Detailed Site Plan	DSP-15031-01
Departure from Design Standards	DDS-648
Departure from Parking and Loading Standards	DPLS-459

Application	General Data	
Project Name: EZ Storage College Park Location: On the south side of Branchville Road, approximately 1,080 feet east of its intersection with Rhode Island Avenue. Applicant/Address: Siena Corporation 8221 Snowden River Parkway Columbia, MD 21045	Planning Board Hearing Date:	05/23/19
	Staff Report Date:	05/07/19
	Date Accepted:	03/18/19
	Planning Board Action Limit:	05/27/19
	Plan Acreage:	1.82
	Zone:	I-2
	Dwelling Units:	N/A
	Gross Floor Area:	122,190 sq. ft.
	Planning Area:	66
	Council District:	01
	Election District:	21
	Municipality:	College Park
	200-Scale Base Map:	210NE05

SUBJECT: Detailed Site Plan DSP-15031-01
Departure from Design Standards DDS-648
Departure from Parking and Loading Standards DPLS-459
Type 2 Tree Conservation Plan TCP2-020-2016-01
EZ Storage, College Park

LANDSCAPE PLAN ezStorage COLLEGE PARK BERWIN (12TH) ELECTION DISTRICT, PRINCE GEORGE'S COUNTY, MARYLAND

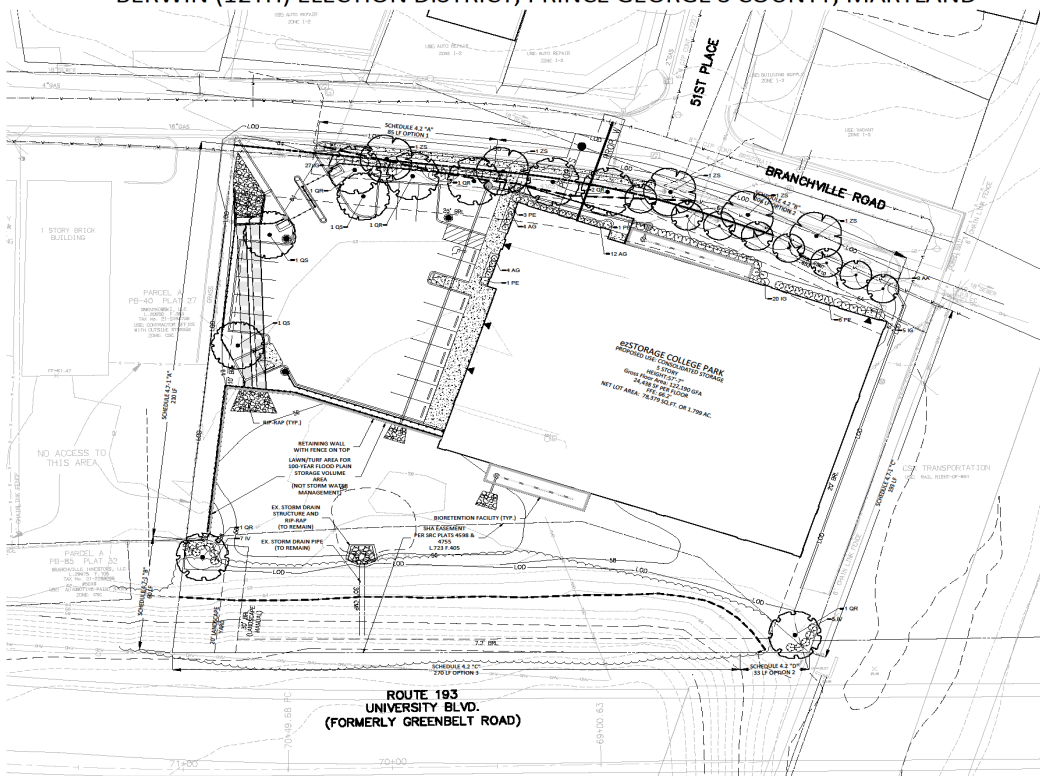
- f. Correct the proposed green area in the Zoning Summary and Site Data chart to reflect the proposed and existing conditions.
- g. Relabel the landscape plan to “Landscape and Lighting Plan.”

- h. Provide plant quantities on the tables to reflect what is presented on the plan.
- i. The Type 2 tree conservation plan (TCP2) shall be revised, as follows:

15. Entry Gate width should be shown on detail #6, Sheet DSP-4.
16. The Landscape Plan provides the appropriate schedule on its detail sheet but the landscape Plan itself does not show or label/callout things like the Landscape Buffers (w/their associated schedule number), as was done on the originally approved Landscape Plan. Nor does the plan itself callout/label the plants to match the Plant Schedule, as was done on the originally approved Landscape Plan. This information needs to be on the Landscape Plan, not just on the detail sheet.

TREE CONSERVATION PLAN

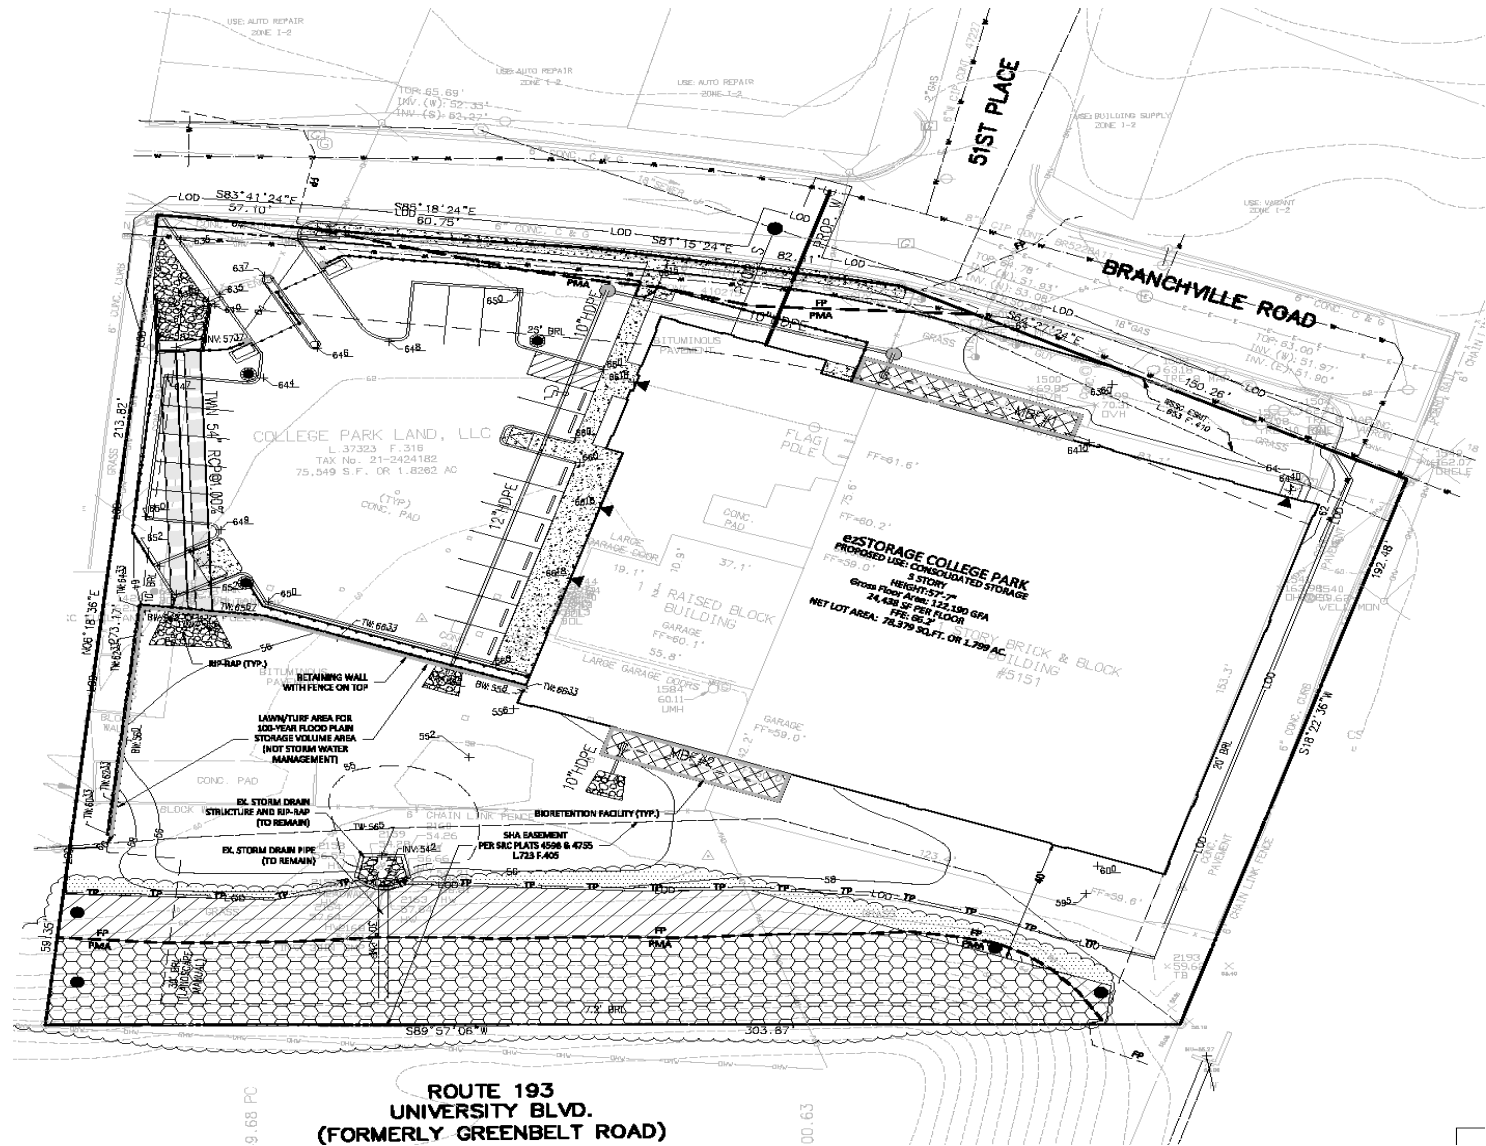
- (1) Revise the TCP2 notes by completing the Invasive Plant Removal notes and providing an invasive species management plan.
 - (2) Label all structures as either existing or proposed.

- (3) Label the proposed retaining wall.
 - (4) Revise the location of all temporary tree protection fencing shown to be placed approximately two feet outside of the limits of disturbance.

- (5) Add a north arrow on the plan.
 - (6) Identify and label all existing and proposed stormdrain easements. Label all woodlands within existing stormdrain easements to remain on-site as “woodland retained-assumed cleared” and all woodlands within proposed stormdrain easements as cleared using the appropriate symbol per the Environmental Technical Manual on the TCP2 plan and legend.

- (7) Show all areas within 40 feet of the front and rear of the proposed building as cleared, and expand the limits of disturbance accordingly on the TCP2 and all relevant sets of plans associated with this DSP application.

- (8) In the TCP2 legend re-label “Woodland Retained Assumed Cleared (WP-NC)” to “Woodland Retained Assumed Cleared (WP-AC),” as labeled on the plan.
 - (9) Revise the TCP worksheet to reflect the same area of net tract woodland retained, not part of requirements, as shown on the plan.
